**Report: TAB REPORT  
Function: Test, Adjust, & Balance  
Date: 12/29/2022**

## **12-26 CULVERS - GREEN BAY, WI (FACILITY TAB)**

### Project Issue Information

**Issue Name :** 1. PRV-1 (Restrooms) Fan is Not Operational.

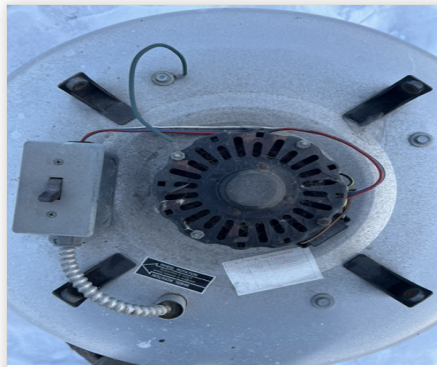
**Description :** Fan is not operational. Motor may need replacement. Recommend service.

**Issue Name :** 2. PRV-4 (Dish Hood HD-3) Fan Not Operational

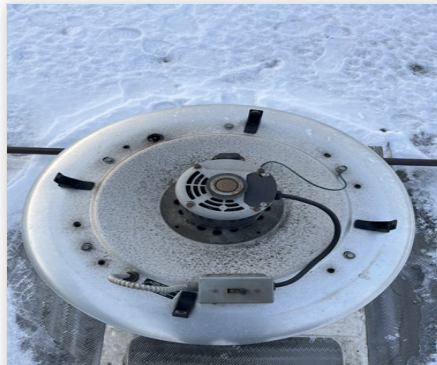
**Description :** Fan is not operational. Needs service. Recommend fan operation is tied into dishwasher operation if repaired to help maintain building pressure.
